SERVICE *No.* 207A BULLETIN

(Supersedes S. B. No. 207)

SUBJECT: Inspection of Weld at Rudder Pedal Assembly
(Part Nos. 40842-04 and 40842-05)

MODELS AFFECTED: PA-18 and PA-18A Super Cub - Serial Nos. 18-1 thru 18-7768
inclusive

Rudder Pedal Assembly
40842-04 and 40842-05

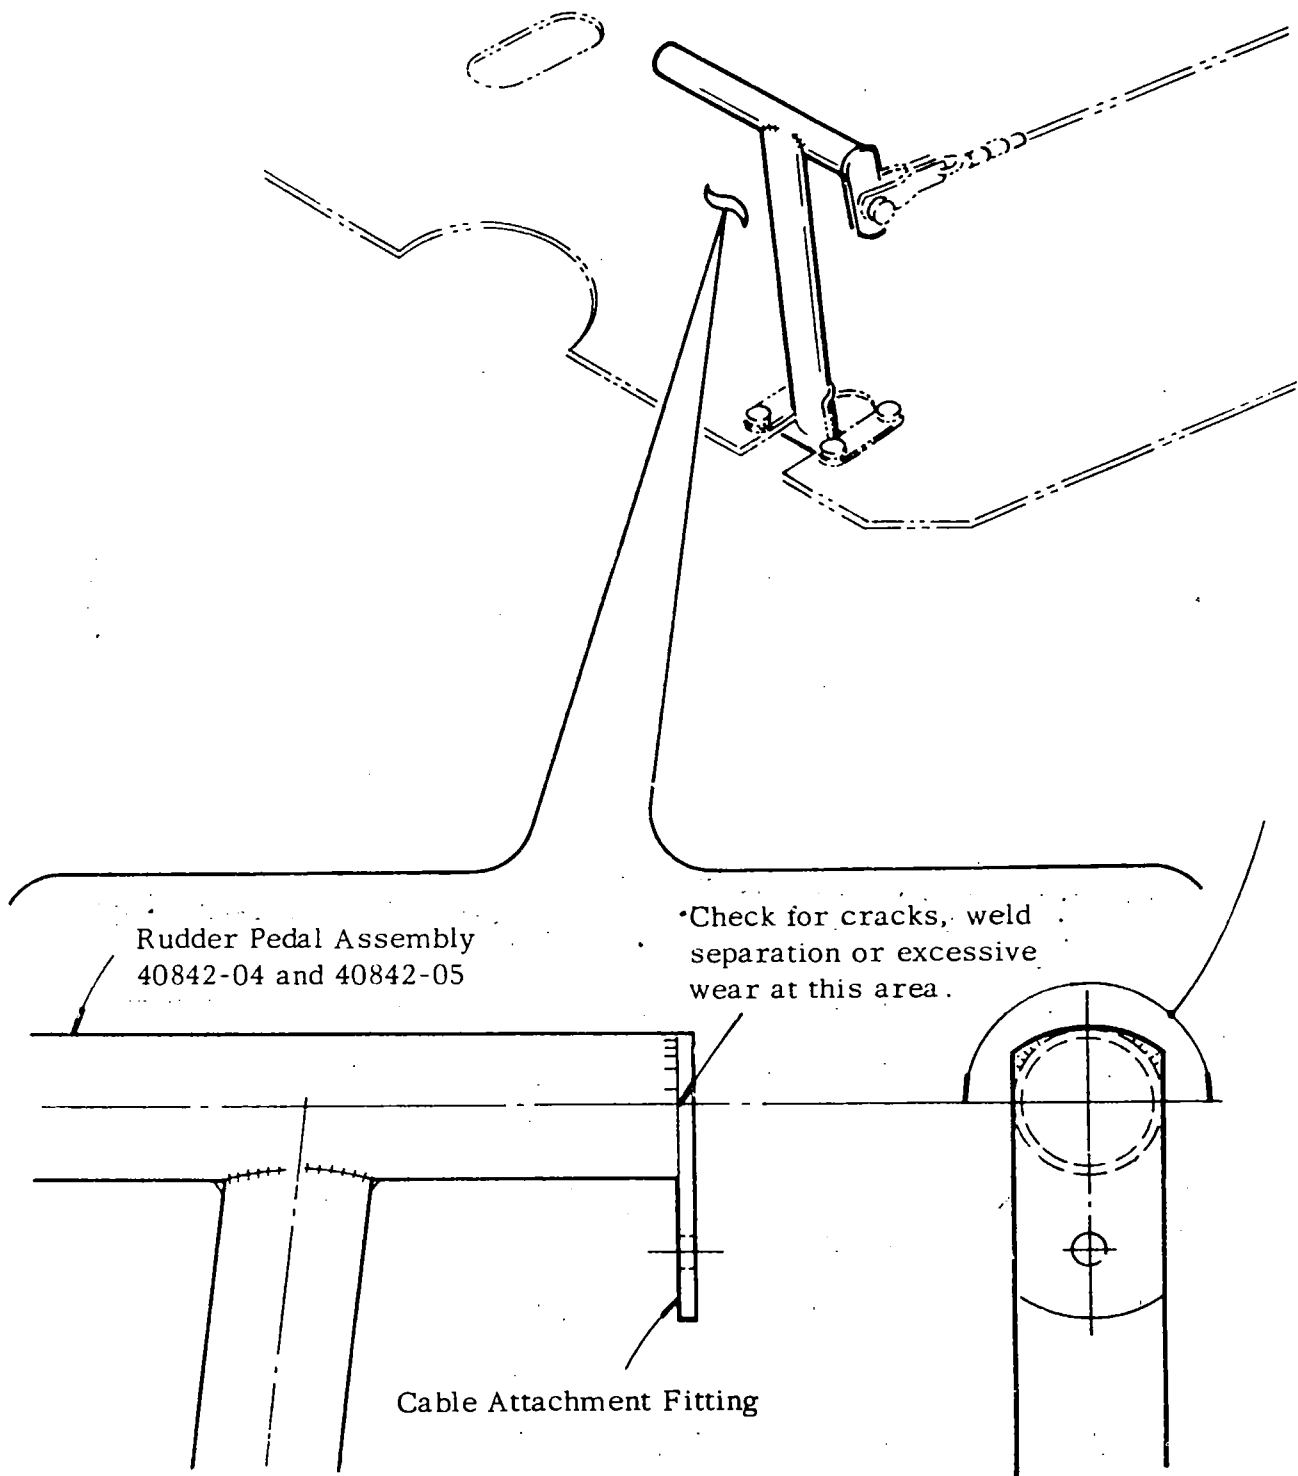
Field service reports indicate that there have been a few instances of weld separation where the rudder pedal cable attachment fitting is welded to the rudder pedal.

It is requested that a visual inspection be made of this weld for any evidence of separation, cracks in the weld, or excessive wear due to long time usage, in area referred to on the reverse side of this Service Bulletin.

If there is no evidence of weld separation, cracks or wear, the length of the weld should be inspected and if the length of the weld conforms to the dimensions shown in the sketch on the reverse side of this Service Bulletin, no further action is required.

•Check for cracks, weld
separation or excessive
wear at this area.

Any cracks in weld, regardless of length of weld or location of crack, shall be cause for rejection of rudder pedal assembly.

If there is evidence of weld separation, cracks, excessive wear, or the length of the weld does not conform to the dimensions referred to on the sketch; the rudder pedal must be replaced prior to further flight.
